**Cadenza Building**  
Earlsfort Terrace, Dublin 2

## MetroLink Environmental Impact Assessment Report (EIAR) Review

Report: DC1763-R05

Figure 1: Extract from EIAR Figure 13.1 Noise and Vibration Monitoring Locations Sheet 7.

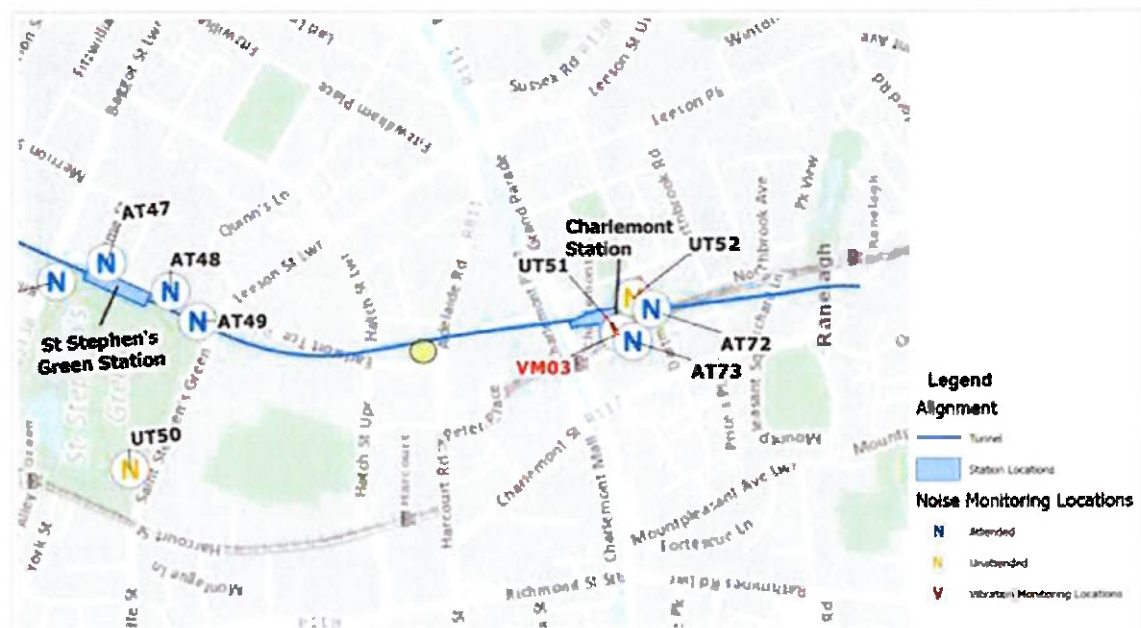
**Comment 1:** We ask TII to provide an explanation as to why no noise or vibration monitoring receptors have been included at the Cadenza building and to clarify that they will carry out baseline noise and vibration monitoring prior to the commencement of the MetroLink project.

Figure 2: Extract from Figure 13.2 Construction Noise Assessment Locations Sheet 29.

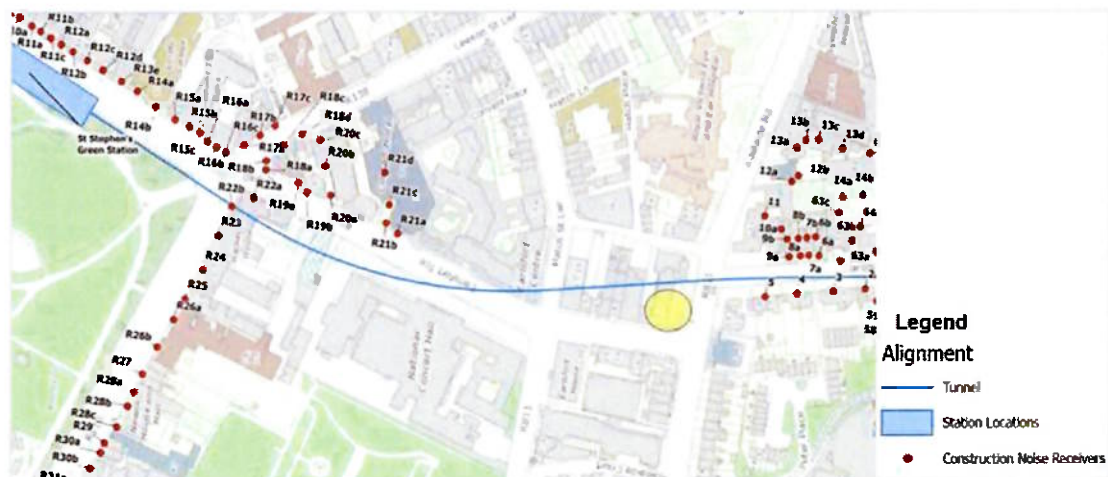
**Comment 5:** We ask TII to provide an explanation as to why no construction noise assessment locations have been included at the Cadenza building and to clarify that they will carry out additional construction noise impact calculations to outline the predicted construction noise levels at the Cadenza building should construction activities take place at this location.

Figure 6: Extract from EIAR Figure 14.2 Groundborne Noise from Tunnel Boring Machine Sheet 7.

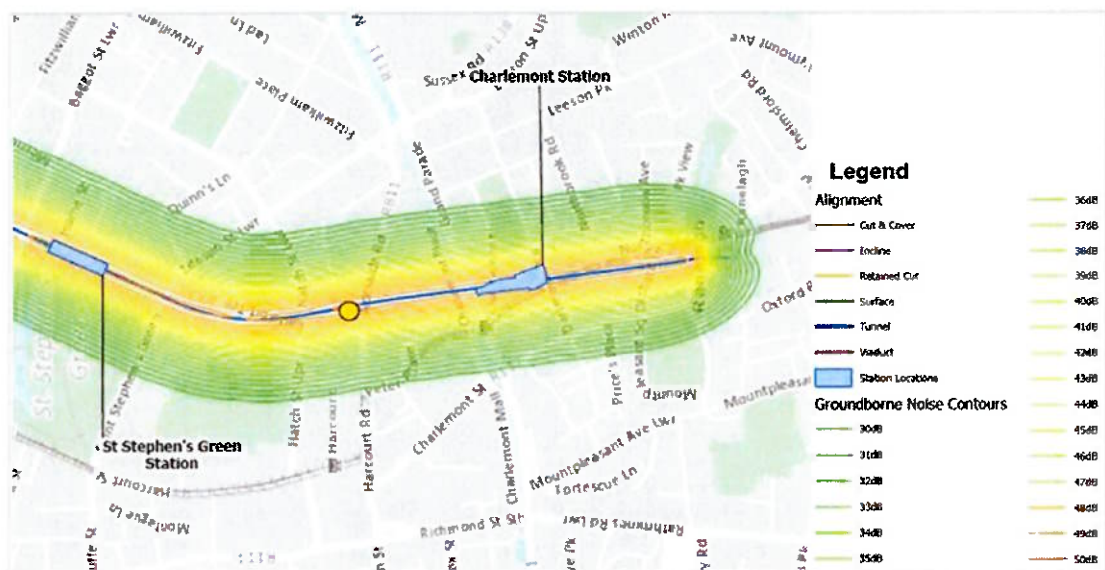
**Comment 12:** The extract from EIAR Figure 14.2 shown above shows a ground borne noise level of 50dB L<sub>Amax,s</sub> at the Cadenza building during construction. Allegro Acoustics considers this level to be unacceptable to the users of the Cadenza building. This level would be clearly audible and is likely to cause disruption to tenant concentration levels, conversations and meetings.

Figure 7: Extract from EIAR Figure 14.6 Groundborne Noise from Operation Sheet 7.

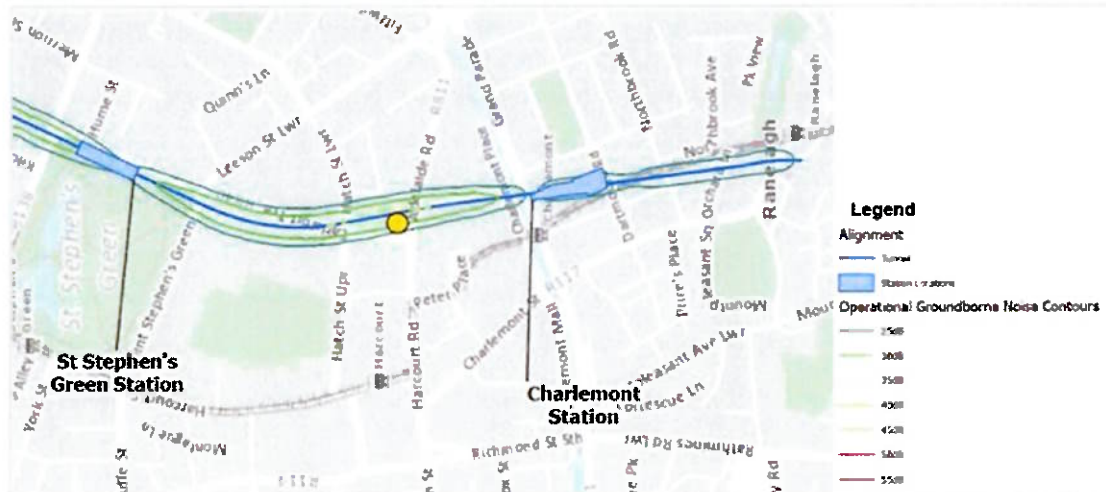
**Comment 15:** The extract from EIAR Figure 14.6 shown above shows a ground borne noise level of 37dB  $L_{Amax,s}$  at the Cadenza building during operation. Allegro Acoustics considers this level to be unacceptable to the users of the Cadenza building. This level would be audible and is likely to cause disruption to tenant concentration levels and / or annoyance to users of the space.
